Corporate Report

Originator's
Files OZ 04/037 W2

DATE: February 7, 2006

SUBJECT: **Information Report**
Official Plan Amendment and Rezoning Applications
To permit two 18 storey condominium tenure apartment
buildings containing 418 apartment units and a community
park
1075 Southdown Road and 2007 Lakeshore Road West
Northeast corner of Lakeshore Road West and Southdown
Road
Owner: Stonebrook Properties Inc.
Applicant: Glen Schnarr and Associates Inc.
Bill 20

SITE PLAN

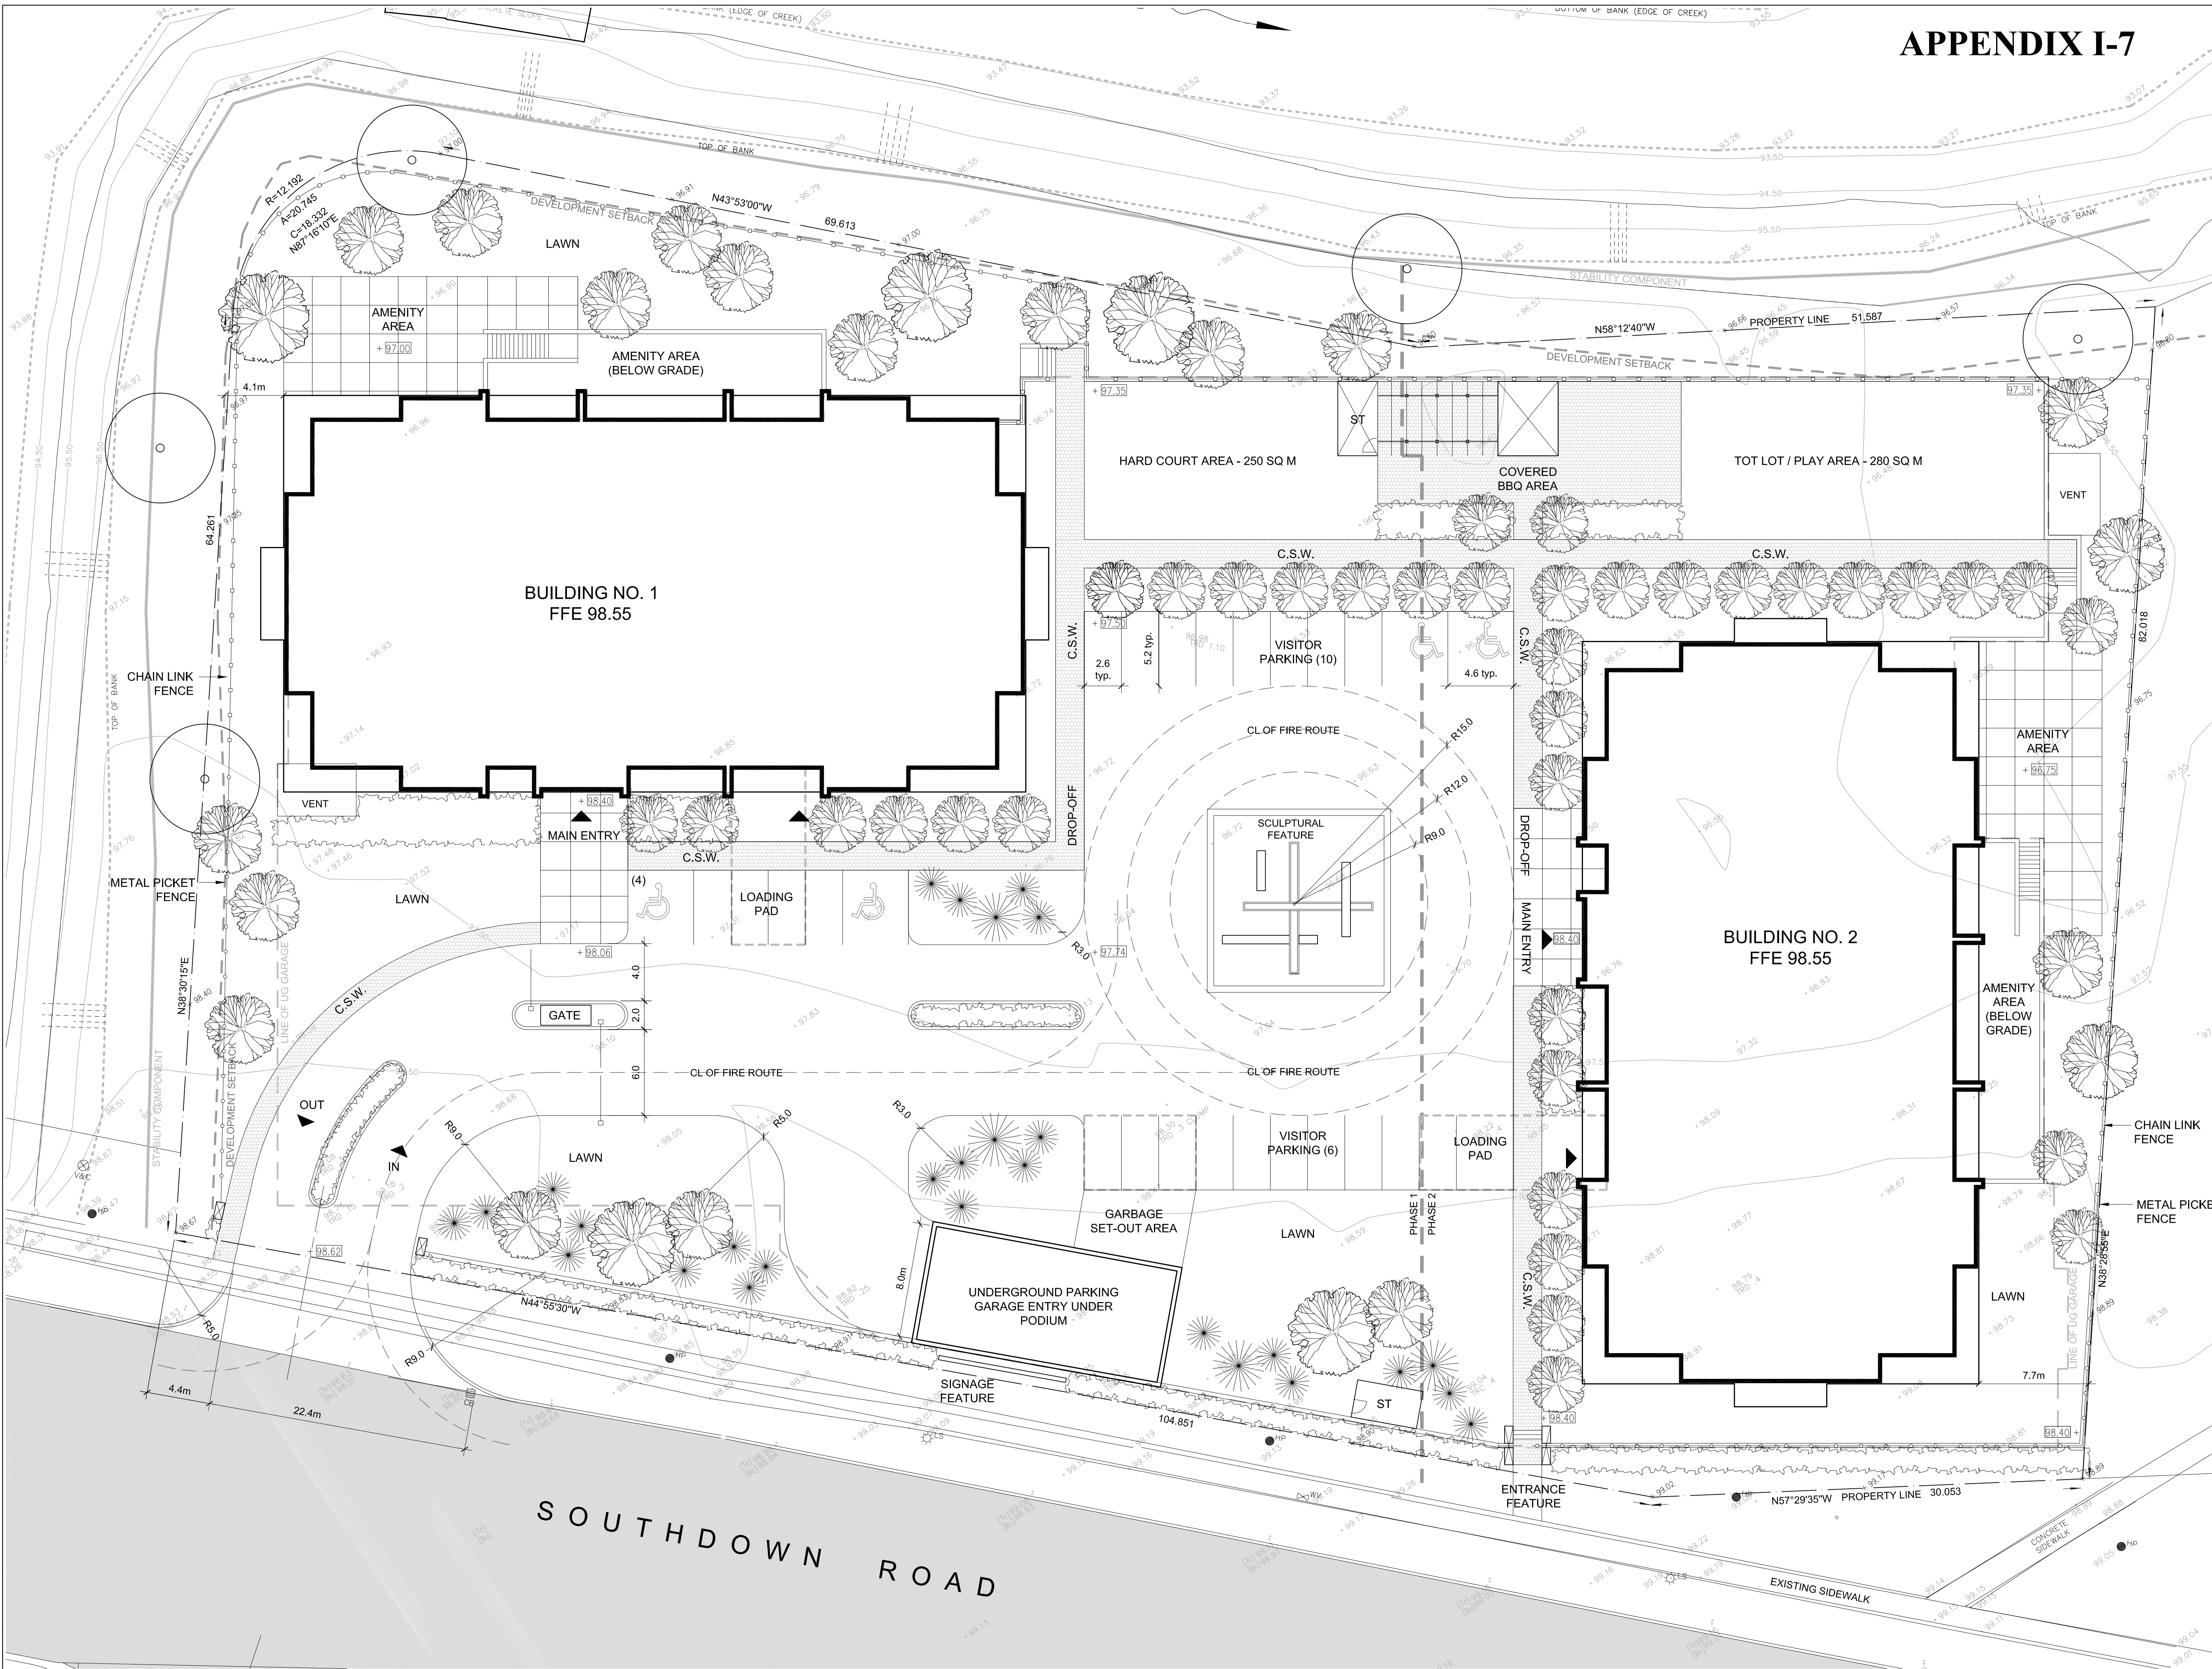
Consideration should also be given to relocating the underground parking garage entrance structure, which is currently shown on the concept site plan as being setback only 1.0 m (3.3 ft.) from the front property line. This one storey structure will isolate the site from Southdown Road and minimize opportunities to promote desirable street related connections and safety.

The concept site plan also depicts a 0 m (0 ft.) setback for the underground parking structure from the required development setback. Credit Valley Conservation (CVC) has indicated that all lands below the development setback limits should come into City ownership should the applications be approved. To accommodate the proposed underground structure, excavation, shoring and grading activities would be required within City owned lands contrary to CVC requirements. An alternative solution will need to be achieved prior to preparing the Supplementary Report for Planning and Development Committee's consideration.
